# ENDL TEXAS

Date: 9 October 2006  
 To: T10 Technical Committee  
 From: Ralph O. Weber  
 Subject: Security Association Model for SPC-4

**Figure x1 — SA relationships**

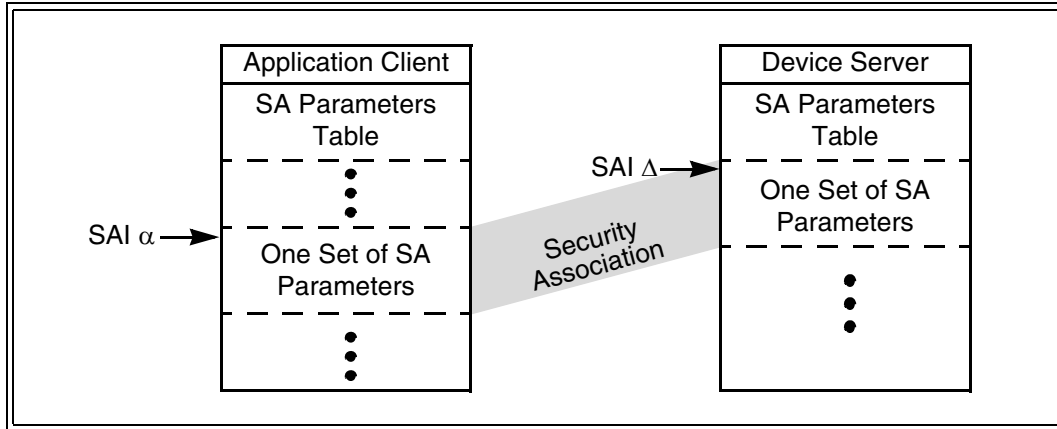
Figure x1 shows the relationship between application clients and device servers with respect to SAs.

In both the application client and the device server, the SA parameters are modelled as being stored in an indexed array and the SAI identifies one set of SA parameters within that array. The application client and device server are not required to store the parameters for any given SA in the same array locations. In order to support this implementation flexibility, a single SA is modelled as having two different SAI values (i.e., one for the application client and one for the device server).
